SUBJECT: Case # 00806: Development Agreement - Greenvale School

SUPPLEMENTARY REPORT

SUBJECT: Case # 00806: Development Agreement - Greenvale School

DETAILS (SCHEDULE N)

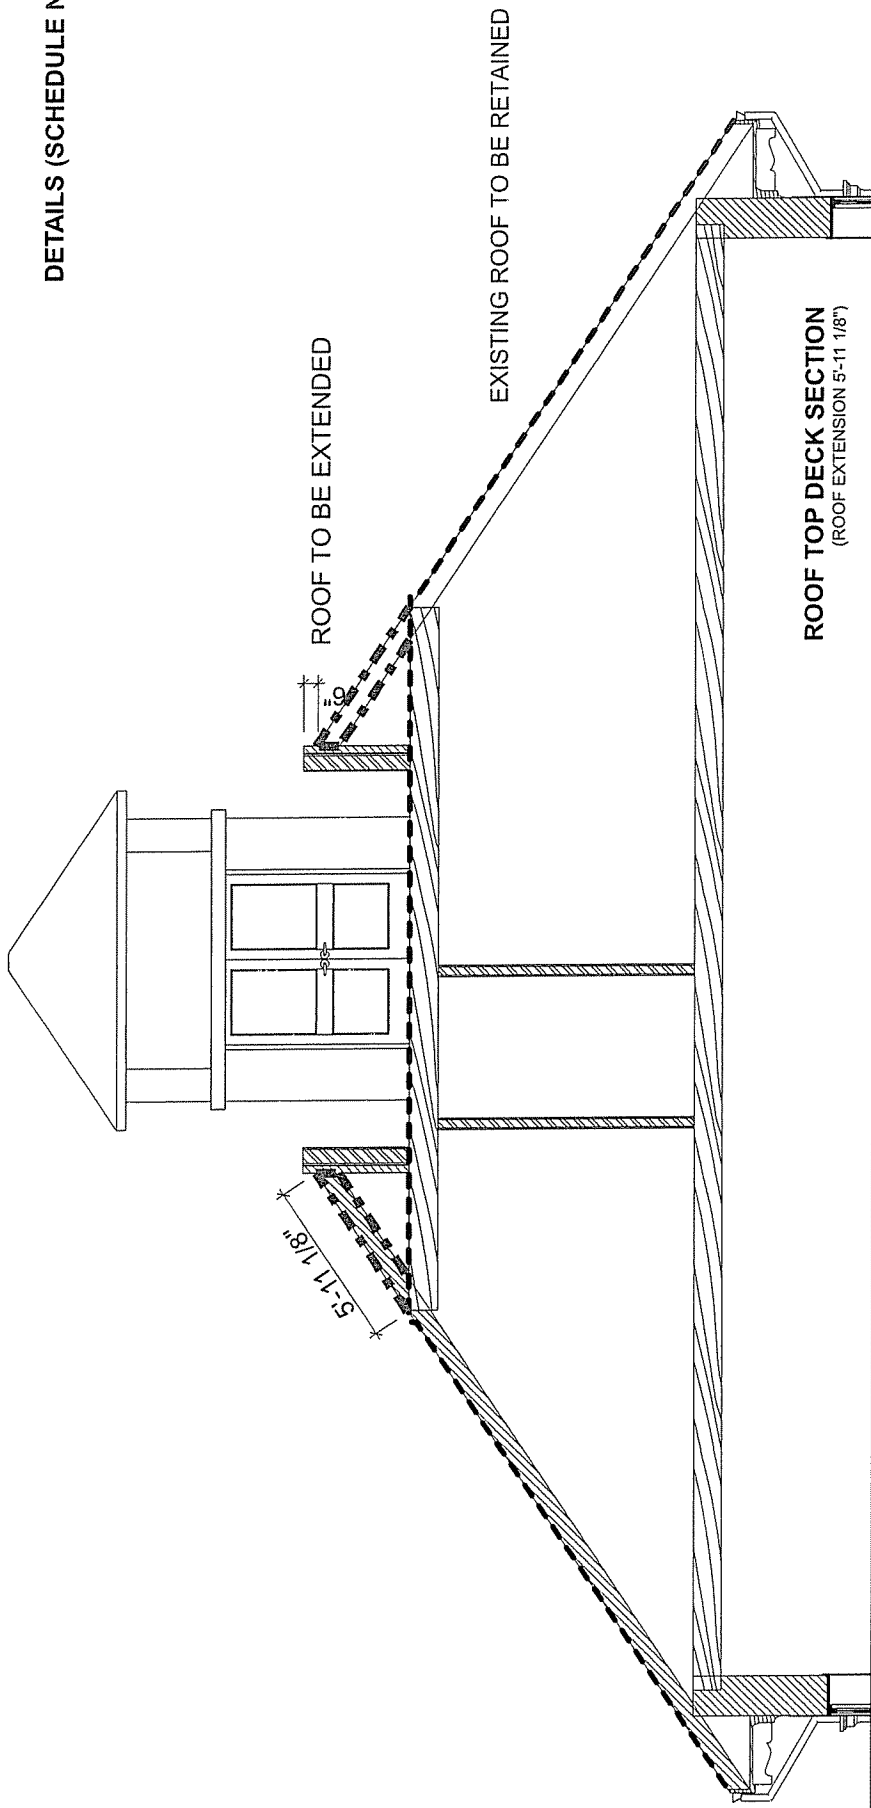
The Heritage Advisory Committee's second recommendation, that replacement rain gutters be in keeping with the tradition of the building, is already contained in Section 3.4.2 (h) of the agreement, and therefore, no further changes are required.

Specifically, Schedule N contains a design detail showing how the new gutters, down spouts and drop outlets will look. This detail is based on the original architect's drawings, and will ensure that these elements will be in keeping with the tradition of the building. It is interesting to note that while Andrew Cobb specified copper, very old painted wood gutters are currently on the building and these appear to be original. The development agreement directs the developer to consider using materials resembling the copper originally specified by Cobb.

- (g) Landscaping may be carried out as generally described by the text and schedules of this agreement;
 - (h) New gutters, down spouts, and drop outlets, as shown on Schedule N, may replace the existing painted wood gutters. New materials which resemble the copper gutter and down spouts originally specified by Andrew Cobb, shall be considered.
